RE: 232 Silver Spring Road
Wilton, Connecticut

I have reviewed your comments about the above referenced property and have the following responses.

STORMWATER PLAN

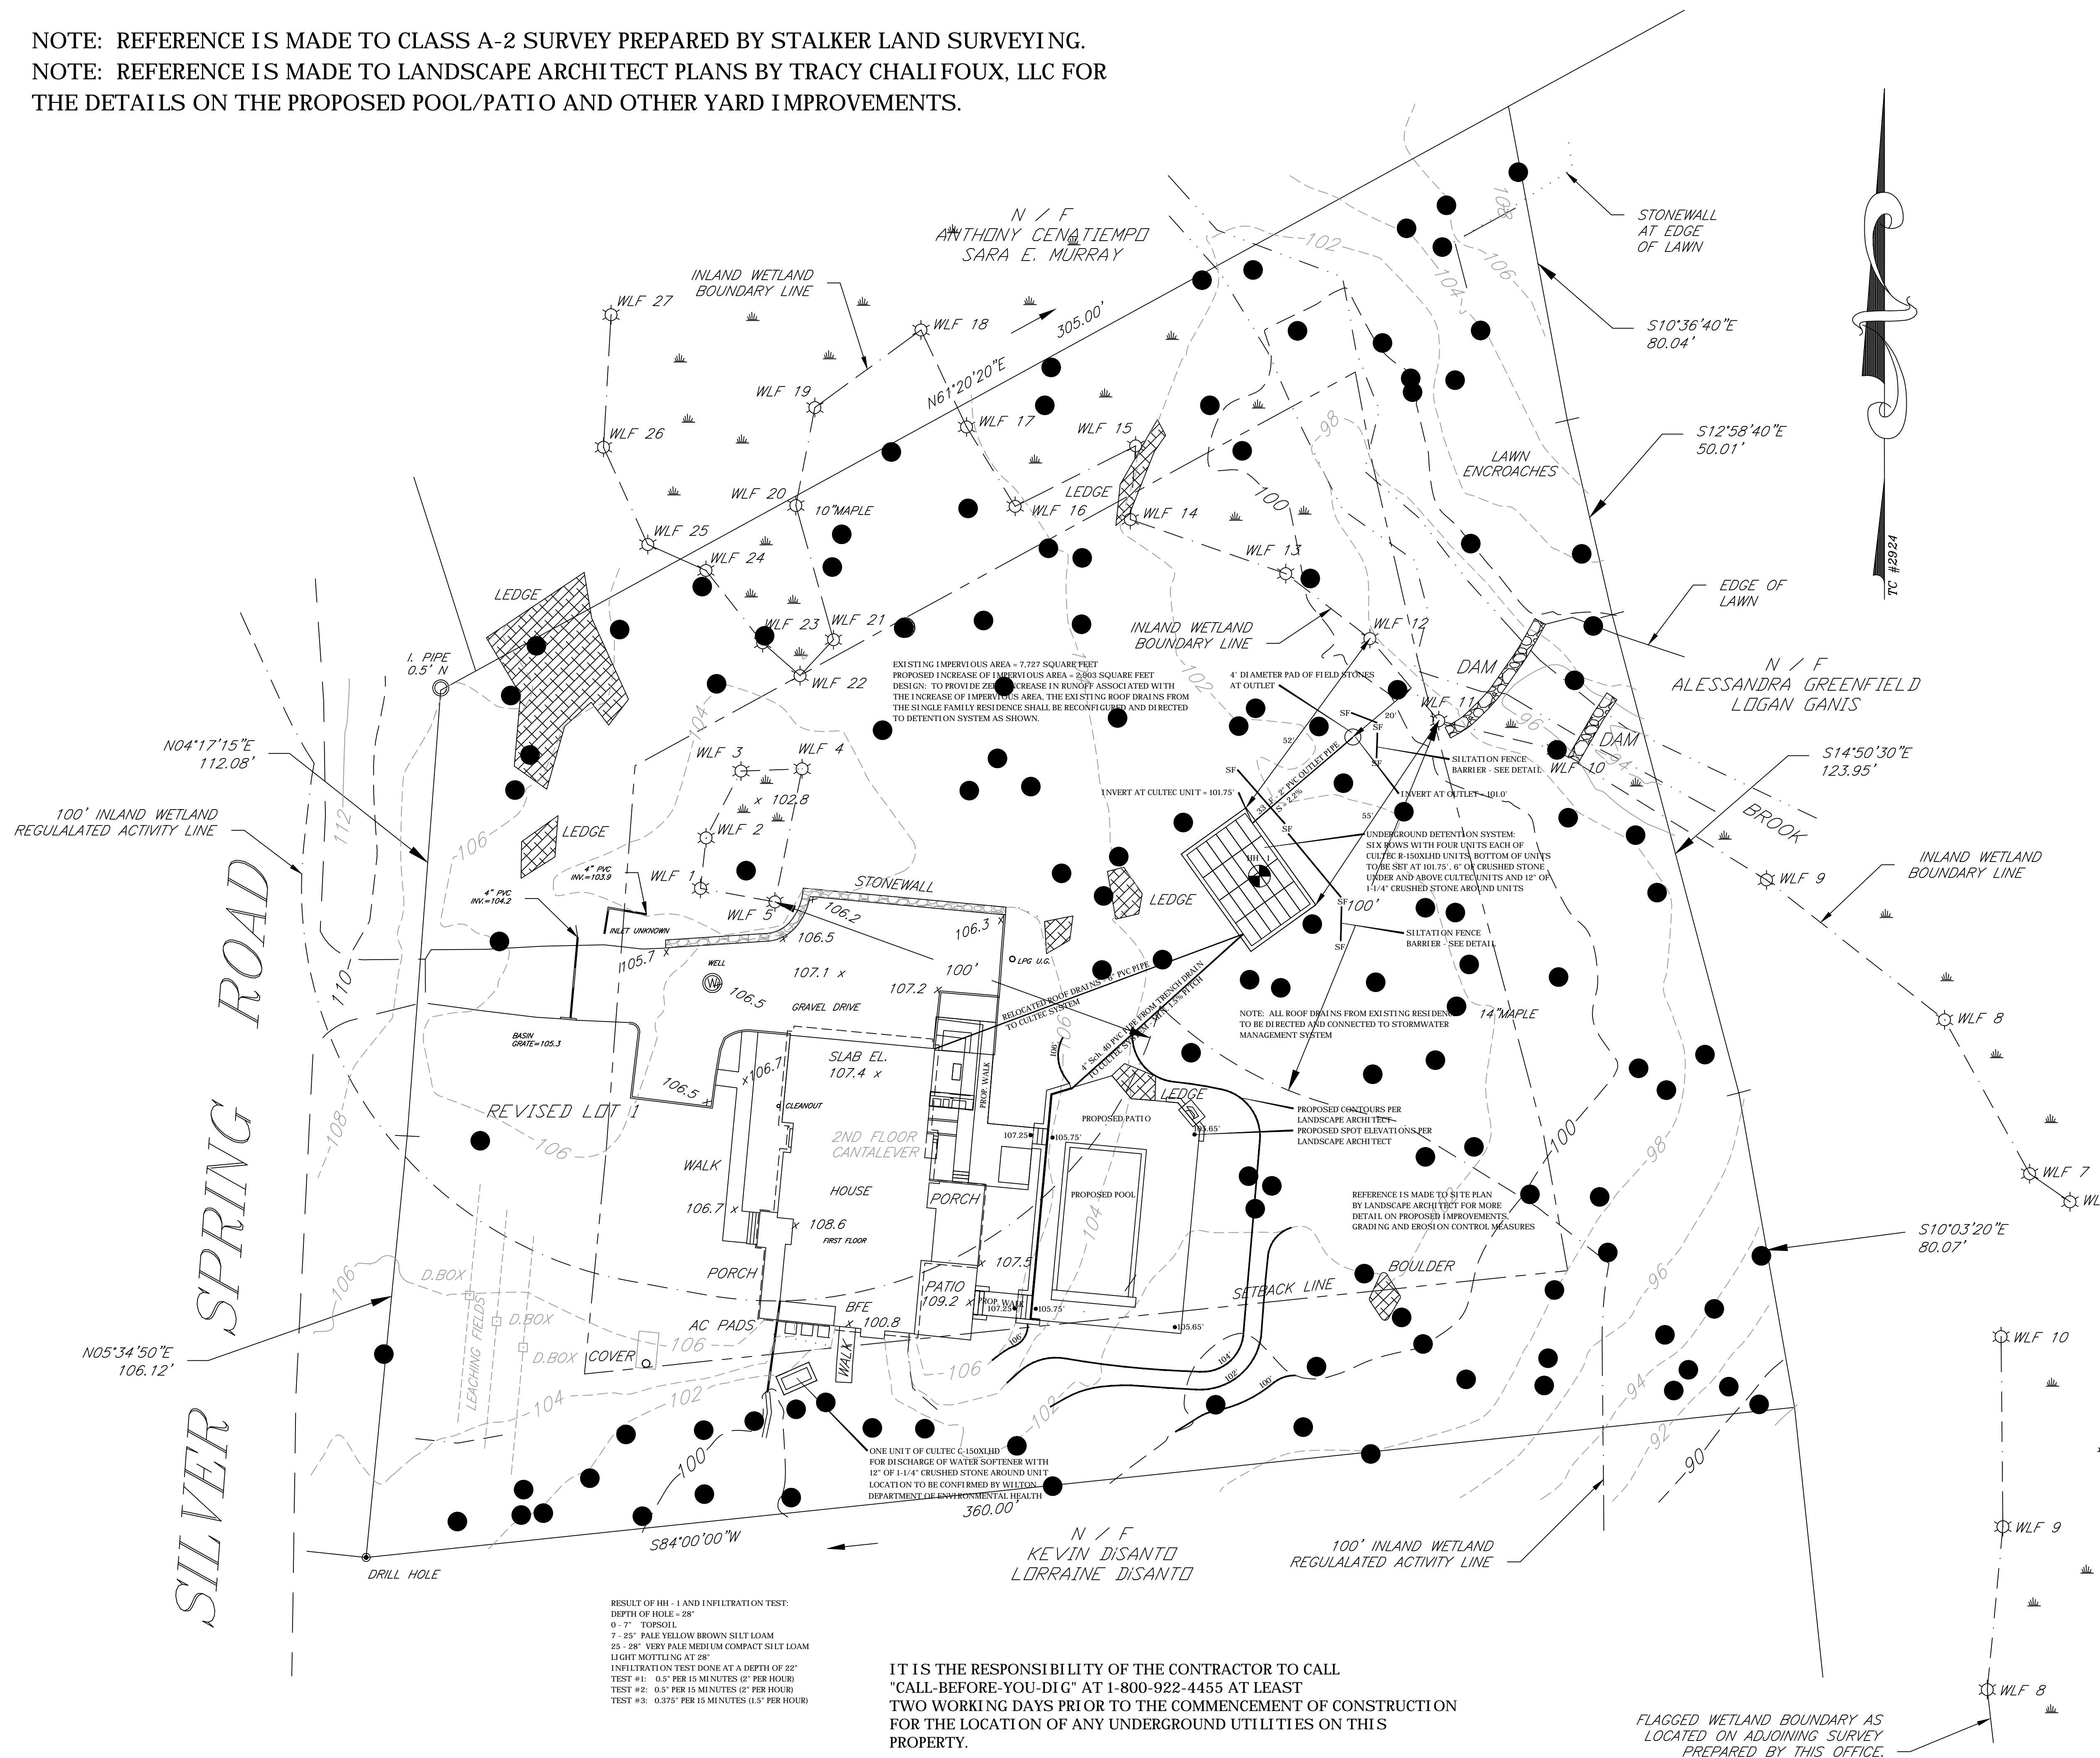
1. The trench drain per the landscape architect and grading has been added to my plan.
2. All of the roof drains are to be directed to the underground Cultec system.
3. The trench drain will be connected to the Cultec system as shown on my plan.
The small area which drains to the trench drain does not change the peak rate of runoff directed to the Cultec system, so the system size remains the same.
4. A note has been added stating that the Department of Environmental Health must approve the location of the system for the water softener.
5. Landscape architect is providing detail of boulder retaining wall.
6. Understood.
